CITY OF ALBUQUERQUE

RE: **4936 Pan American**
Grading and Drainage Plan
Engineer's Stamp Date: 10/23/17
Hydrology File: F17D032

Based upon the information provided in your submittal received 10/24/17, the Grading and Drainage Plan cannot be approved for Grading or Building Permit until the following comments are addressed.

FIRM MAP 35001C0138H

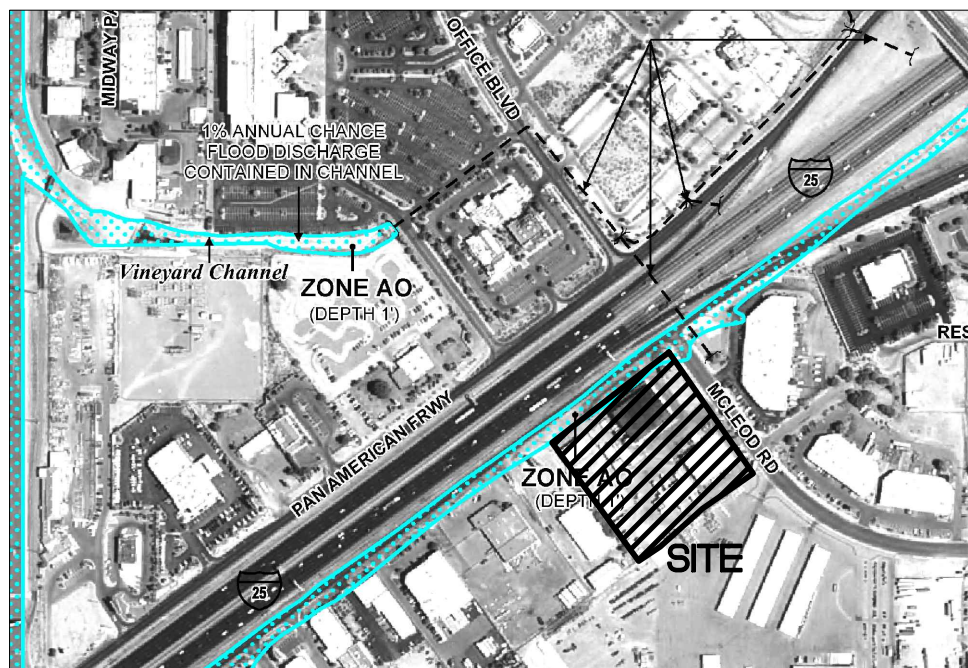
1. Written concurrence must be obtained from NMDOT D3 Drainage that this project can proceed. Please contact Tim Trujillo P.E (TimothyR.Trujillo@state.nm.us).
2. Update the statement under the FIRM viewports to state that a portion of this project is located in a floodplain (AO-1').
3. How much fill/cut is being placed in the floodplain? Quantify the cut/fill volume exclusive of work in the DOT ROW and show where the displaced volume will be provided. The concern for the City is that the floodplain is being filled and displaced into the adjacent properties- mainly the DOT ROW, but also the adjoining parcels north and south.

DATE	10/11/2017	SHEET	C1.1
SCALE	AS NOTED	OF	2

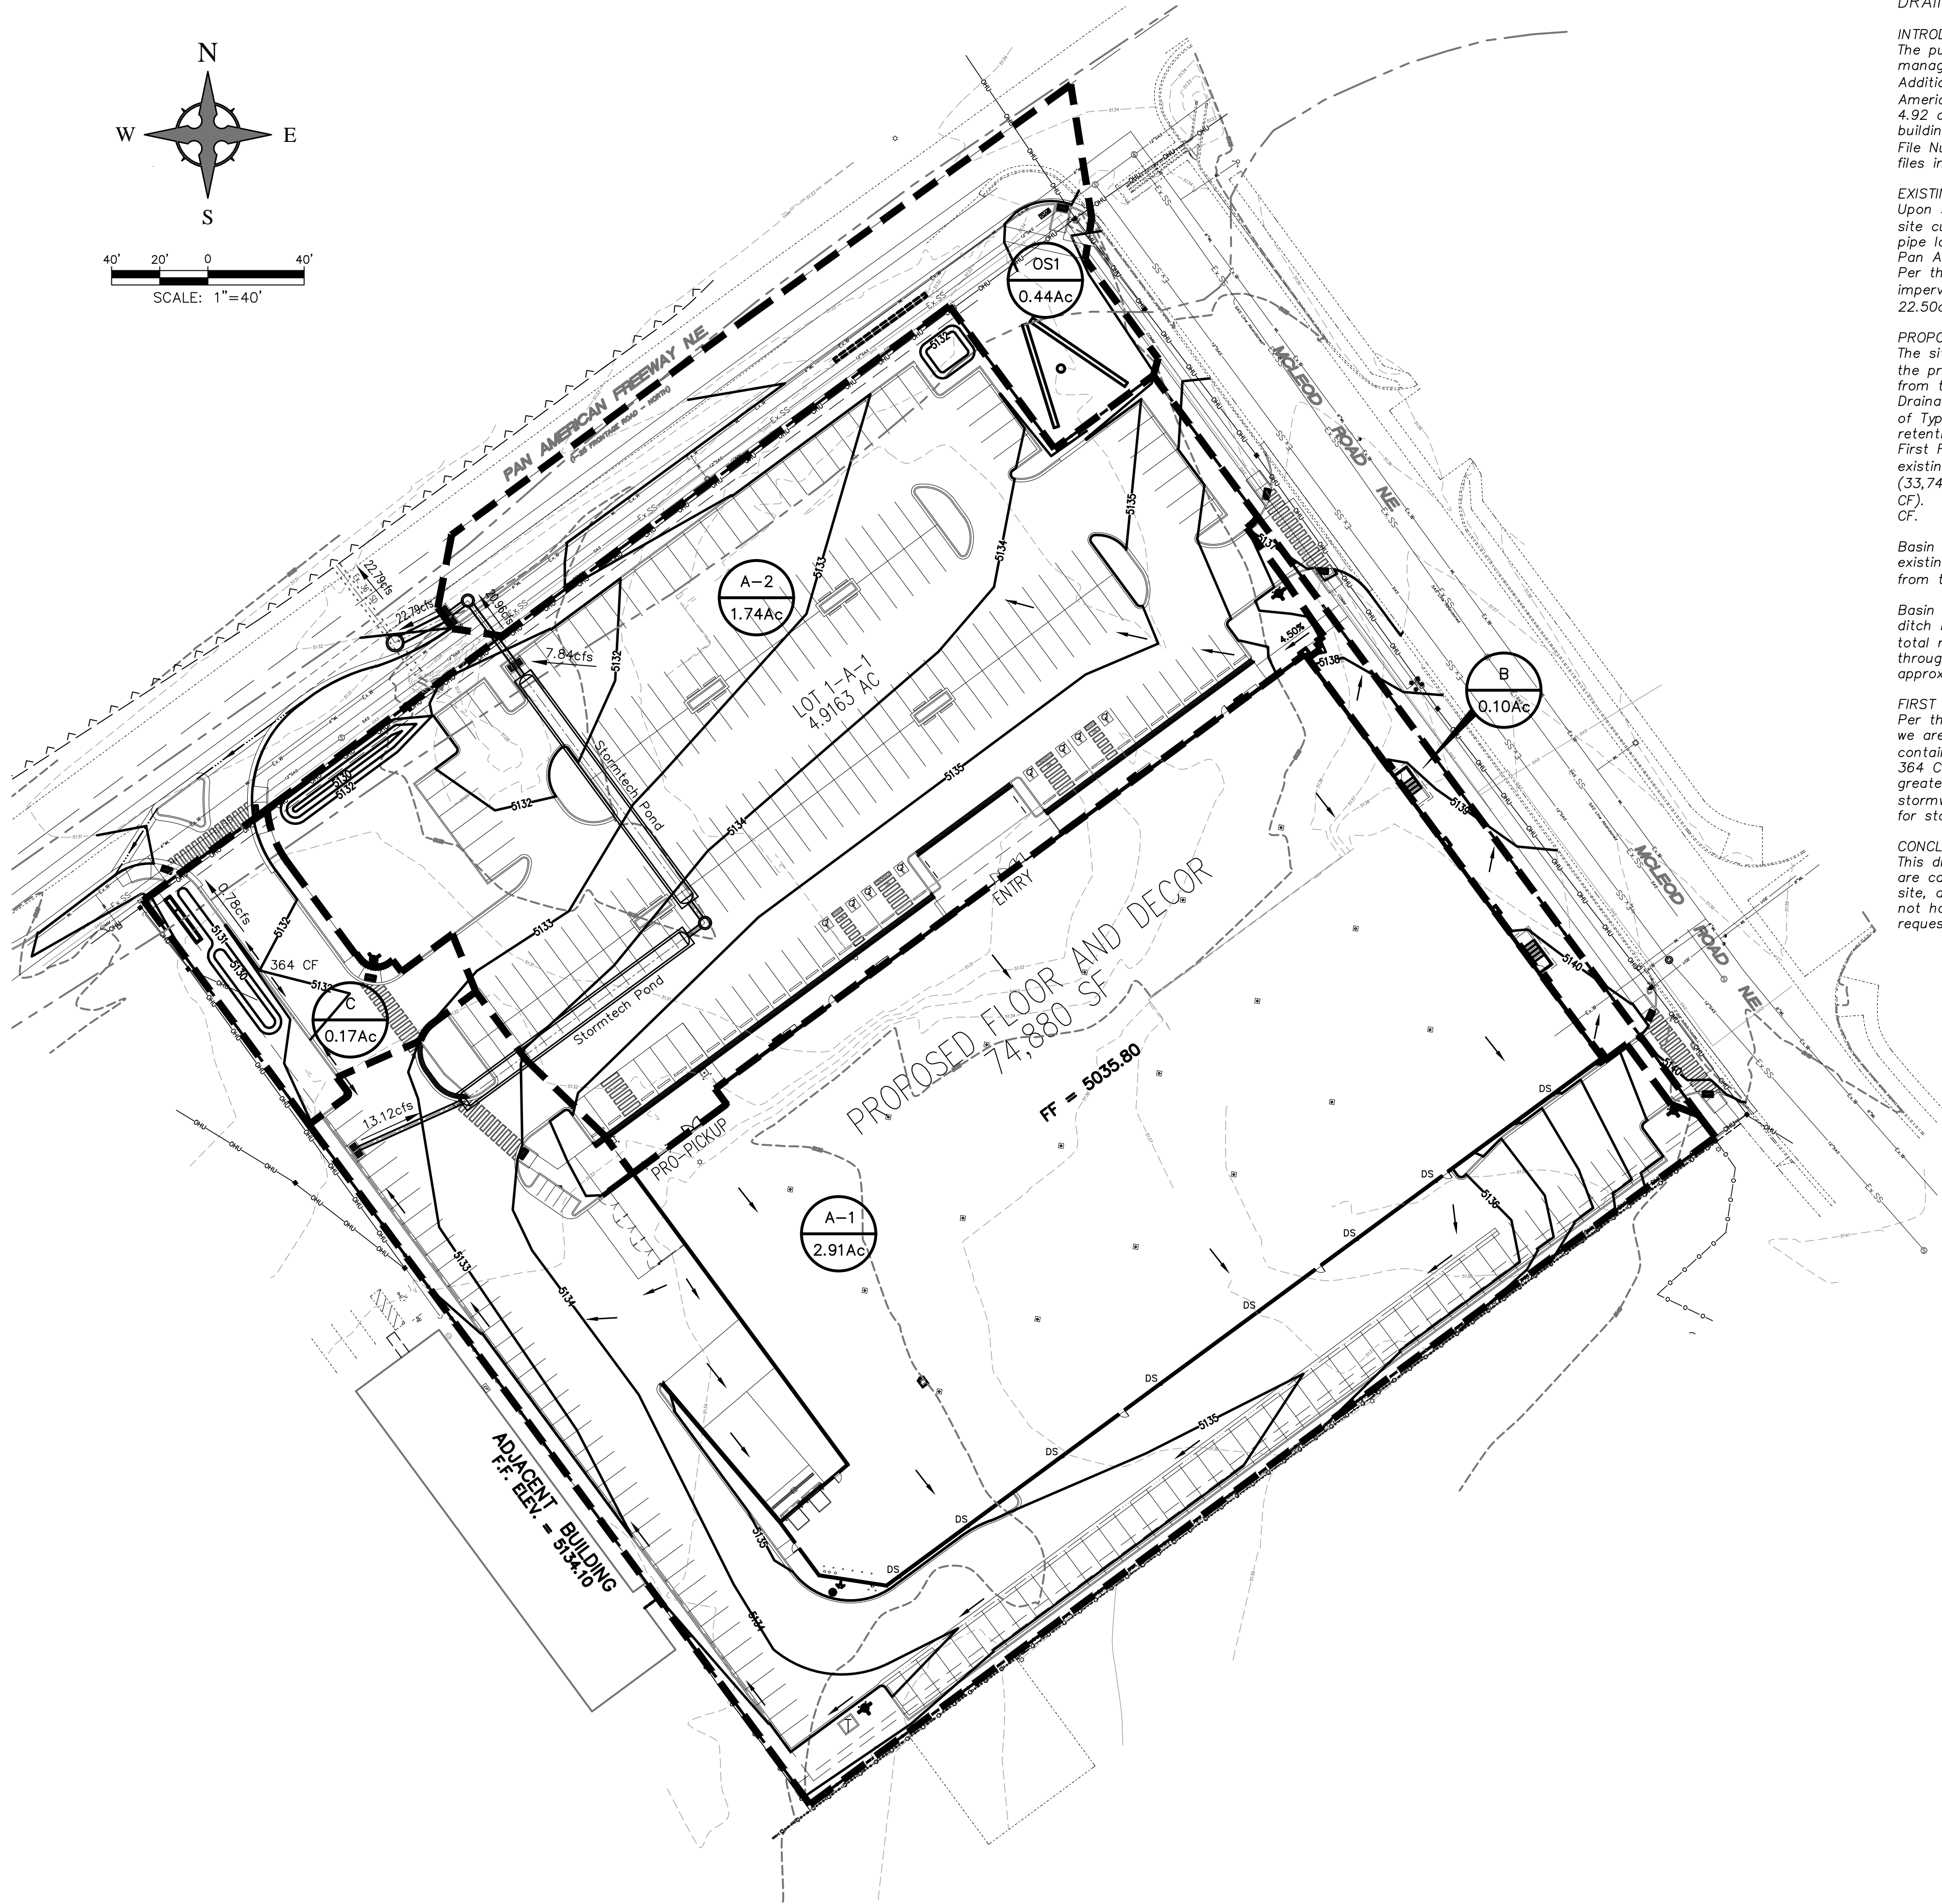
4. The site must be platted.
5. Payment of the Fee-in-Lieu is required for the first flush bypass volume (51CF x \$8.00/CF, per sheet C1.3).
6. How does the roof drain? Include clarifying language, flow direction, soffits, gutters, etc...
